TSB170003

Fault Codes 1867 and 2962 Caused by Water Intrusion

Figure 2, Normal EGR Temperature Sensor Water Jacket.

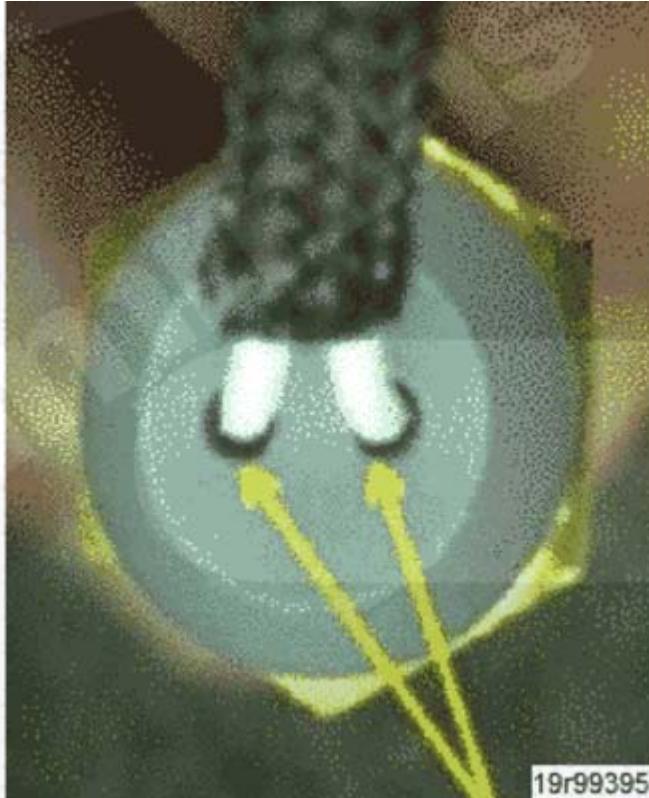
- Verify Fault Code 1867 or 2962 is active.
- Inspect EGR temperature sensor at water jacket for strained wires and distortion. See Figures 2 and 3 below for examples of a normal and distorted EGR temperature sensor water jacket.

- If EGR temperature sensor water jacket is distorted, replace EGR temperature sensor and route the wiring harness per the Service Instructions section below.
